RE: Water Right Permit No. 63-32237

SUBJECT: Licensing Review of Water Right 63-32237

STATE OF IDAHO
DEPARTMENT OF WATER RESOURCES
BENEFICIAL USE FIELD REPORT

Permit 63-32237 Place of use

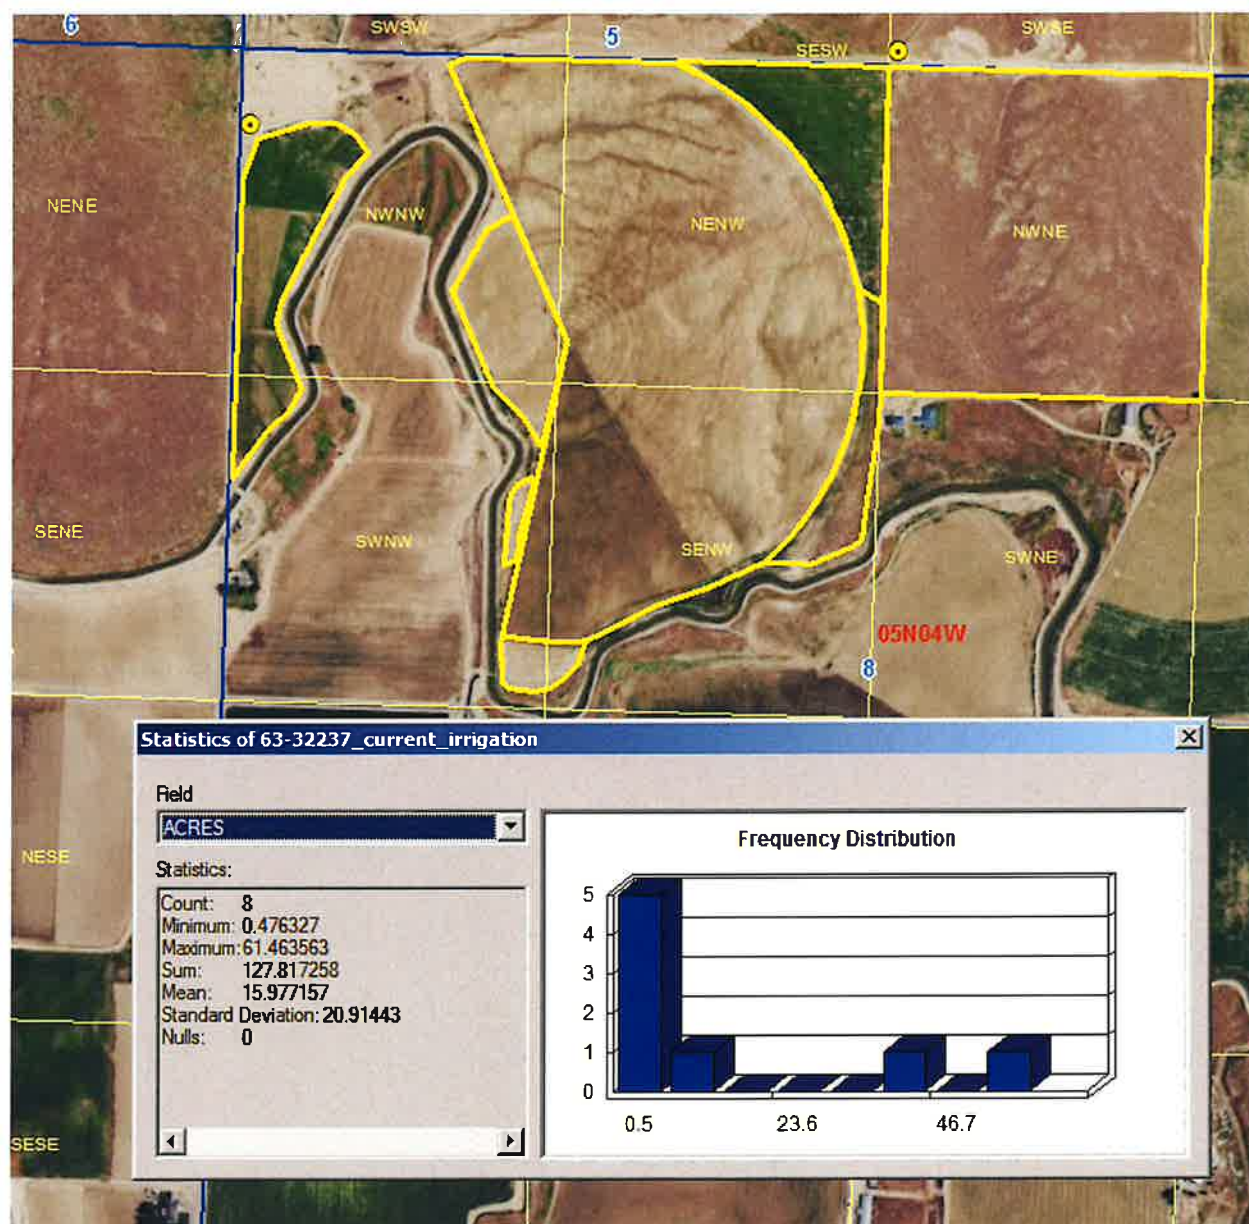
The field examiner request a permissible place of use, which we can give for the acres irrigated. As you can see from this map the yellow border shows the total number of acres (128 acres) that were irrigated on this property. The remaining acres are authorized by water right permit 63-33654.

I do need to let you know that I am going to have to use the Current Irrigation Shape you supplied for the permissible place of Use shape for this permit instead to the Permissible Place of Use Shape you sent in the email and included in your field report. Unless all of the lands in a permissible place of use are irrigated during the development period, we cannot include the non-irrigated ground in the permissible place of use. We can only license the things that were done during the development period. Your irrigation shape was 126 acres, and this permit is limited to 105.6 acres. The license will be issued for 106 acres within a 126 acre permissible place of use.

Irrigated Acre Review Permit 63-32237

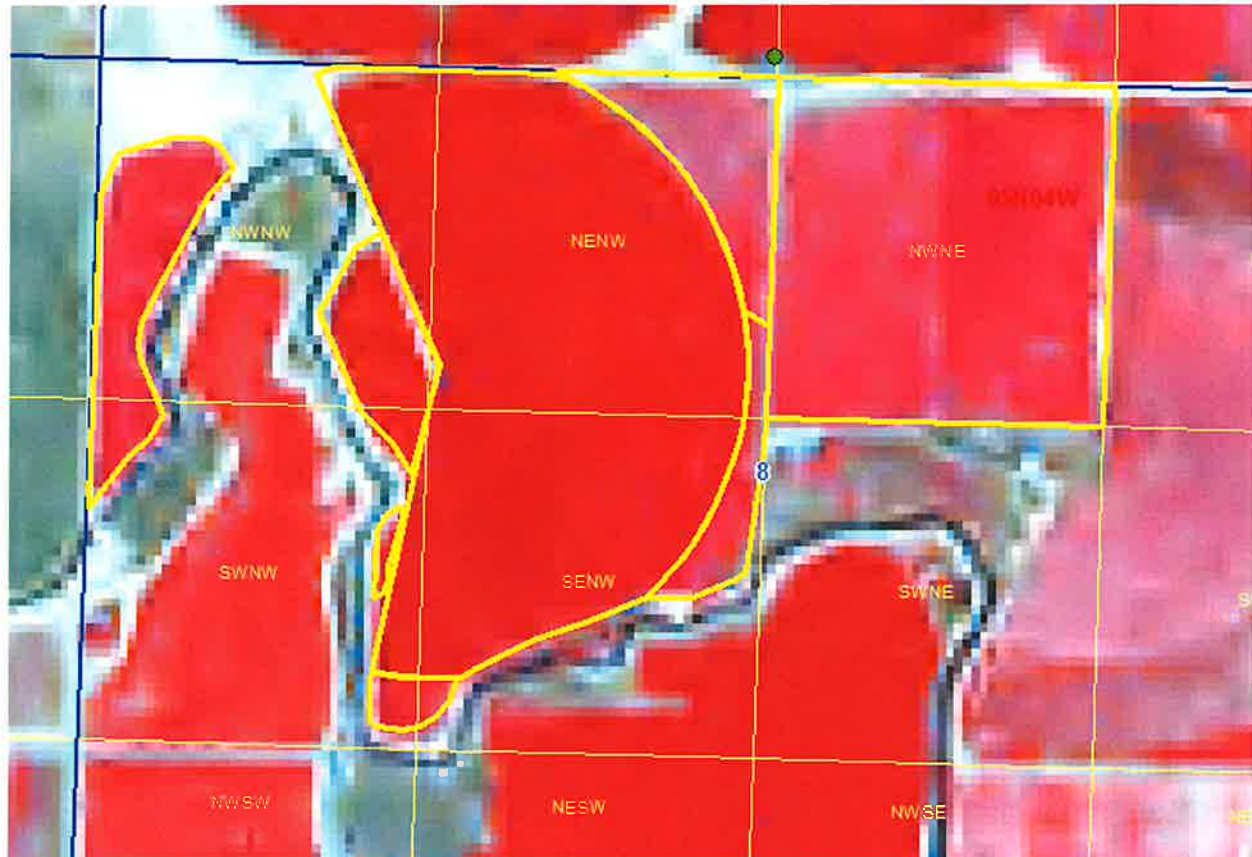
The following is the 7/20/2018 Google Map Aerial Imagery for the place of use for this permit. The current aerial imagery available to the Department doesn't show the irrigation of the lands in the NWNE of Section 8, but this aerial image clearly shows that there is a mainline running down the middle of the 40 acre tract, and some type of measurement lines running off of the mainline.

As you can clearly see the mainline and the sprinkler lines below for the field in the NWNE Section 8
